Product Change Notice (PCN)

PCN Number: PCN-0485149R-01

Product(s) Affected: *CPM1203 Series (CPM1203-02A-02-FRA-M7-67, CPM1203-03A-02-FRA-M7-67, CPM1203-04A-02-FRA-M7-67, CPM1203-05A-02-FRA-M7-67, CPM1203-05B-02-FRA-M7-67, CPM1203-08A-02-FRA-M7-67, CPM1203-02A-02-FRA-M9-67, CPM1203-03A-02-FRA-M9-67, CPM1203-04A-02-FRA-M9-67, CPM1203-05A-02-FRA-M9-67, CPM1203-05B-02-FRA-M9-67, CPM1203-08A-02-FRA-M9-67)*

Visual differences

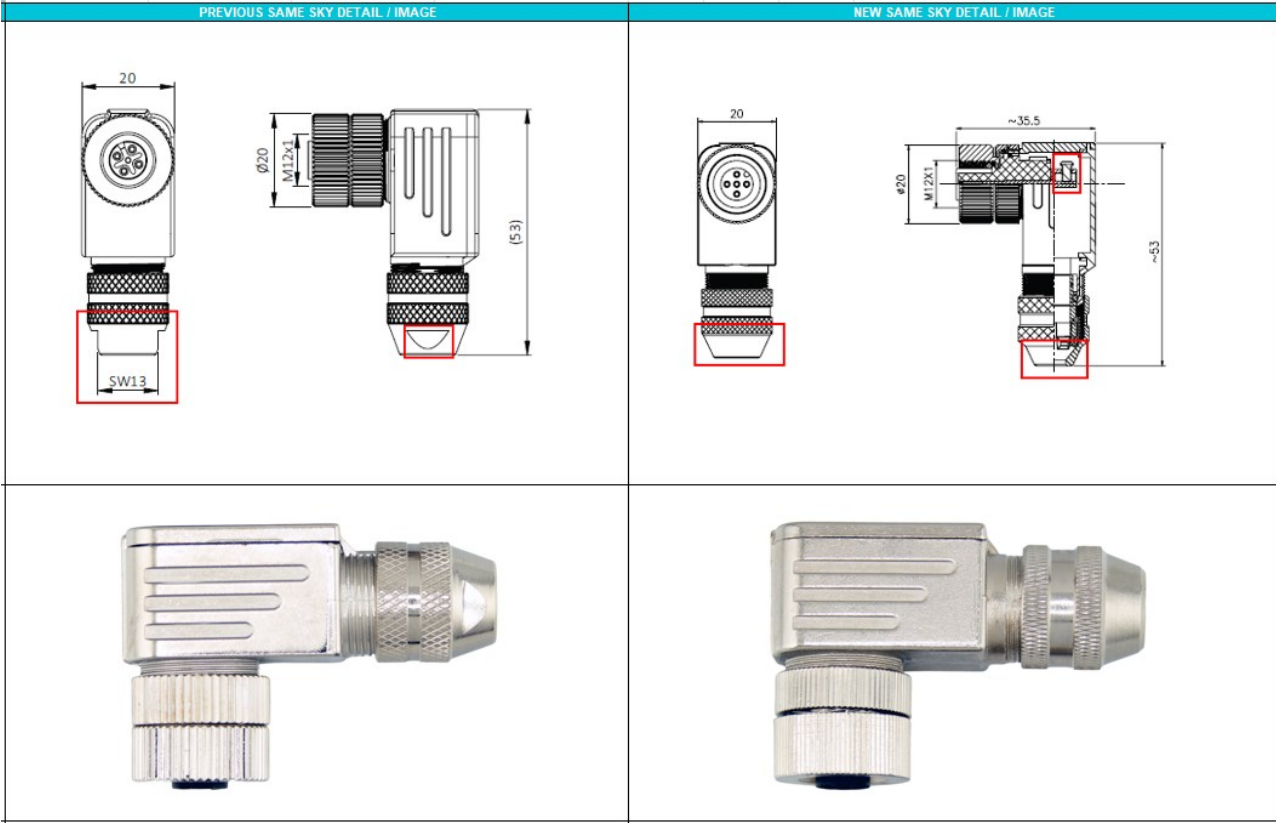
- Previously marked SW13 had flat surfaces for wrenches, our new model does not
- Previous indentation is no longer visible on product
- Screw terminal was previously a Philips and is now a slot head
- Overall appearance is different
